**Identification cards — Contactless
integrated circuit cards — Proximity
cards —**

**Part 3:
Initialization and anticollision**

**AMENDMENT 1: Electromagnetic
disturbance handling and single-size unique
identifier**

Amendment 1 to ISO/IEC 14443-3:2011 was prepared by Joint Technical Committee ISO/IEC JTC 1, *Information technology*, Subcommittee SC 17, *Cards and personal identification*.

Figure 33 — Low EMD time

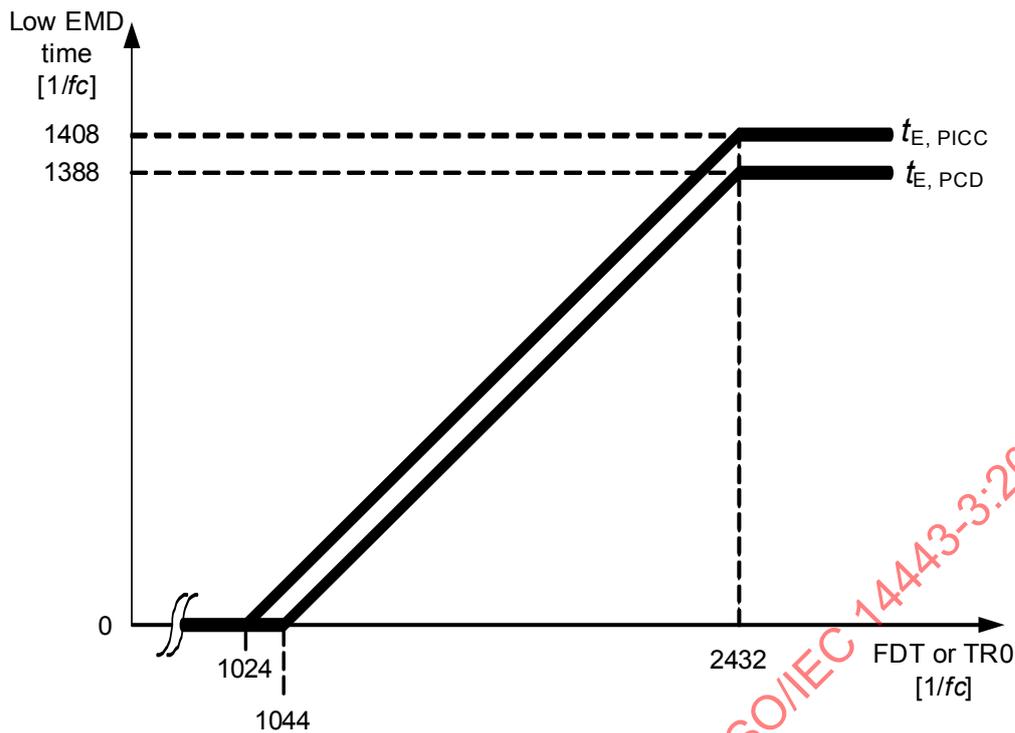
Insert the following new clause after Figure 32:

The low EMD time $t_{E,PICC}$ is the time period before the start of PICC data transmission, when the PICC shall not produce an EMD level higher than the EMD limit as defined in ISO/IEC 14443-2/Amd.1.

This low EMD time $t_{E,PICC}$ has a value of $F - 1024/fc$ with a maximum value of $1408/fc$ where F equals FDT for Type A and $TR0$ for Type B. The value is $0/fc$ for $TR0 \leq 1024/fc$.

The low EMD time $t_{E,PCD}$ is the time period to allow the PCD to recover from electromagnetic disturbances.

The PCD shall be ready to process a PICC frame no later than $t_{E,PCD}$ after the last time the EMD level was above the EMD limit as defined in ISO/IEC 14443-2/Amd.1.

This low EMD time $t_{E,PCD}$ has a value of $F - 1044/fc$ with a maximum value of $1388/fc$ where F equals FDT for Type A and $TR0$ for Type B. The value is $0/fc$ for $TR0 \leq 1044/fc$.

The low EMD time for PCD and PICC are illustrated in Figure 33.
